Access Compliance Report

Public Rights-of-Way

(Curb Ramps)

Intersection ID: 12170	Main Street: S_POPLAR_ST	Cross Street: W_4TH_ST	Location:	N
ADA ID: 83EE530B67A4	Ramp Type: PerpDiag	Initial Pass/Fail: Pass	Overall Compliance: No	Severity Score: 0
Codes/Mitigation Info/Possible Solution		Field Measurements/Component Compliance

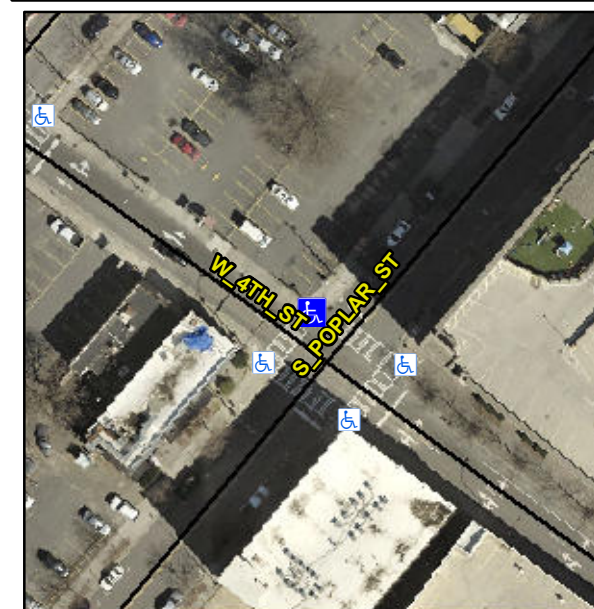
R304.2.1, R304.2.2-Perp, R304.3.2-Para, R304.5.3, R305.2

Compliance	Description	Data	Compliance	Description	Data
N/A	Ramp Length (in)	70.0	Yes	Ramp Slope (%)	6.3
Yes	Ramp Width (in)	48.0	Yes	Ramp XSlope (%)	1.1
N/A	Flare Type LT	Sloped	N/A	Flare Type RT	N/A
N/A	Flare Slope LT (%)	2.6	Yes	Flare Slope RT (%)	8.5
N/A	Flare Traversable LT?	Yes	N/A	Flare Traversable RT?	Yes
No	Landing Length (in)	34.0	Yes	DWS Provided?	Yes
Yes	Landing Width (in)	54.0	Yes	DWS Contrast?	Yes
No	Landing Slope (%)	4.3	Yes	DWS Length (in)	24.0
No	Landing X Slope (%)	3.7	Yes	DWS Full Width?	Yes
N/A	Landing Curb? (Y/N)	No	No	DWS Offset (in)	6.0
N/A	Shared Landing?	No			
Yes	Gutter Ponding?	No	Yes	Gutter Slope (%)	2.2
Yes	Gutter Lip Ht (in)	0.0	Yes	Gutter X Slope (%)	0.8
N/A	Painted X Walk1?	Yes	N/A	Painted X Walk2?	Yes
	X Walk 1 Direction	To SW		X Walk 2 Direction	To SE
N/A	X Walk 1 Width (in)	112.0	N/A	X Walk 2 Width (in)	113.0
	X Walk 1 Slope (%)	0.7		X Walk 2 Slope (%)	0.3
	X Walk 1 X Slope (%)	2.1		X Walk 2 X Slope (%)	0.8

Yes	Ramp inside XWalk1?	Yes	Yes	Ramp inside XWalk2?	Yes
	Road Slope (%)	2.2	N/A	Clear Space?	Yes
	Road X Slope (%)	0.9	Yes	Clear Space to XWalk (in)	93.0
Yes	Any Obstructions?	No	Yes	Storm Grate/Utility Hazard?	No
	Obstruction Type			Storm Grate/Utility Type	
		N/A			N/A
			Yes	Surface Condition? (G/P)	Good

Remove & Replace Curb Ramp With Two New Directional Ramps or Equivalent.
